**RE: GOODLAND COASTAL FARM, 2127 KAIPARA COAST HIGHWAY, KAKANUI 0984
COUNCIL REFs: BUN60406128 (LUC60406129, SUB60406160), WAT60412104 &
DIS60412103**

Thank you for your fifth formal s92 request dated 19 May 2025 requiring further clarification which we have responded to as follows to allow for public notification:

GEOTECHNICAL RFI LETTER

PLAN CHANGE 120 - 2127 KAIPARA COAST HIGHWAY, MAKARAU

Figure 3: Example of Cross-Section N–N’ showing offset from raised-groundwater failure surfaces (FoS < 1.3).

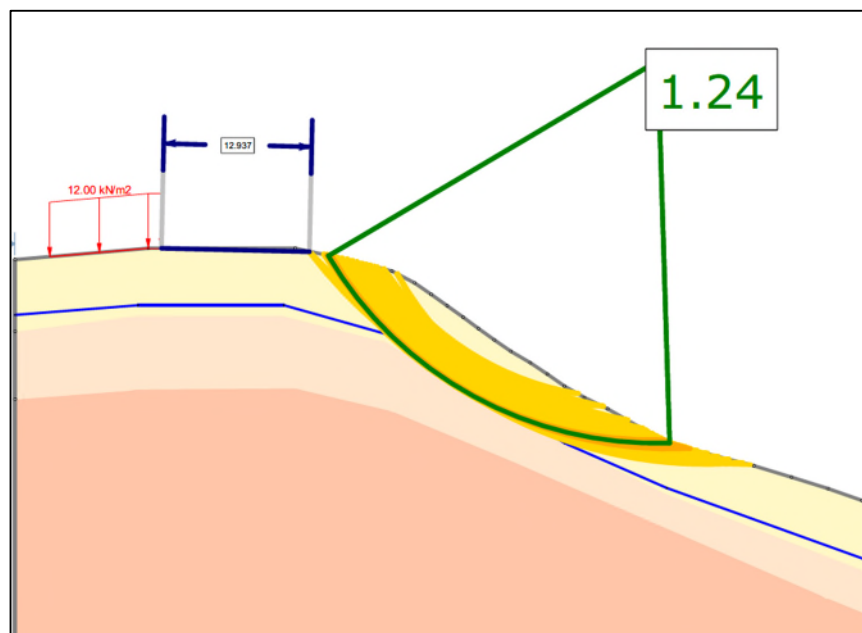
The only exception was Cross-Section N–N’, representing a portion of the accessway located near the crest of the steeper eastern slopes. This analysis returned FoS values below Auckland Council criteria (though all FoS > 1.0), consistent with the shallow movement observed during the 2023 walkover. In response, the proposed accessway alignment was shifted further west, set back from the slope crest. Updated analyses demonstrate compliant FoS along the revised alignment.

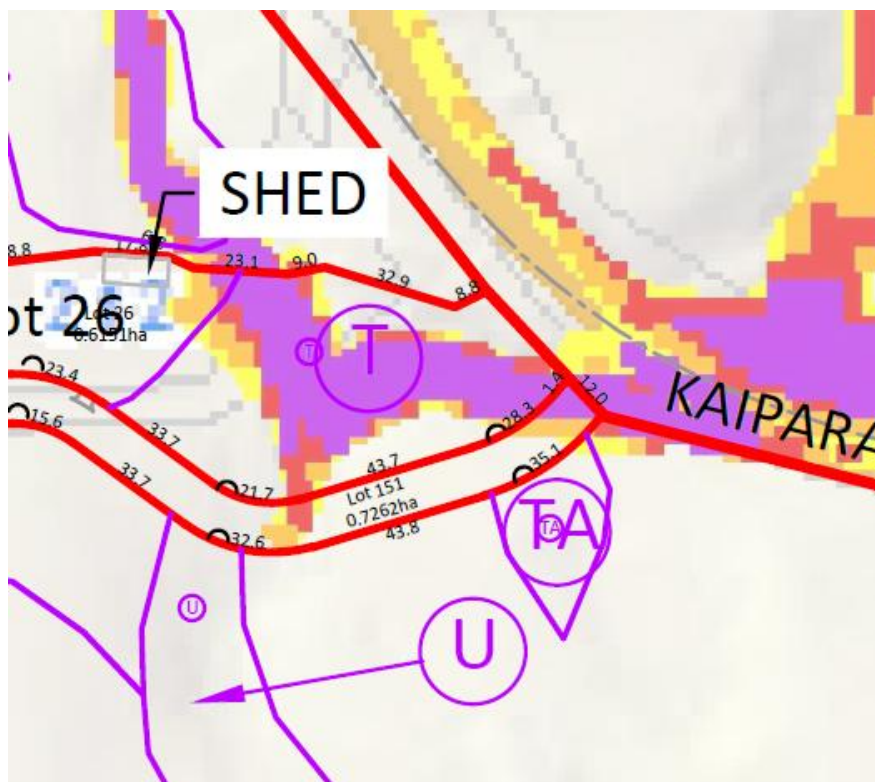
There are two areas of the private access road that cross the very high flood hazard area. These are shown in the diagram below:

The entrance private road from Kaipara Coast Highway. Note that the hazard extends across the existing highway:

The access road activity is deemed to be less sensitive to natural hazards as the gully crossings are designed to cater for the 1% AEP flood event flows. The hazard is therefore in the acceptable category according to Table E36.3.1B.2.

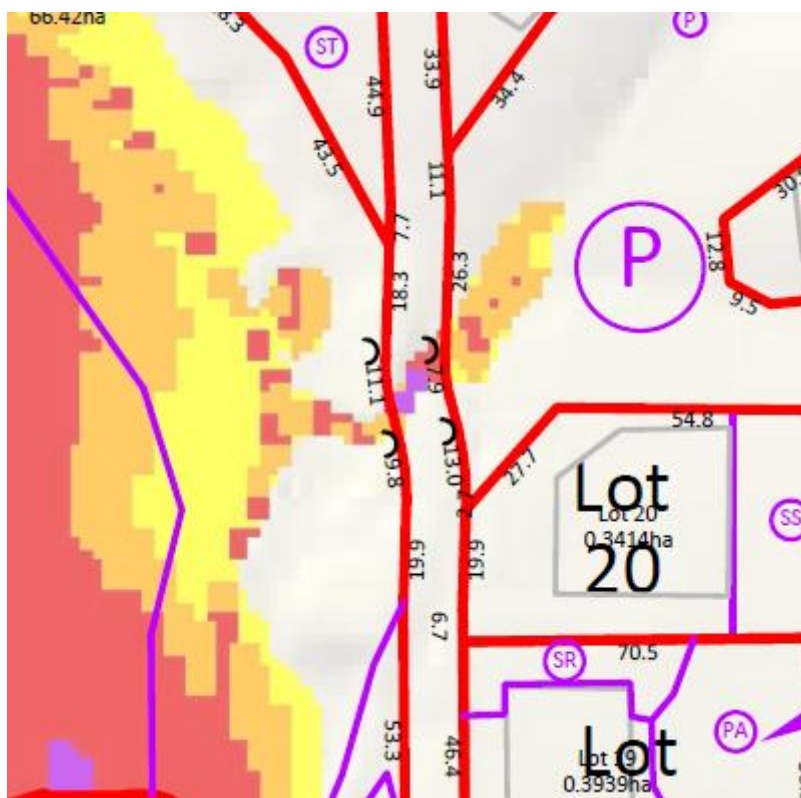
And the private access road that crosses a minor gully feature near lot 20:
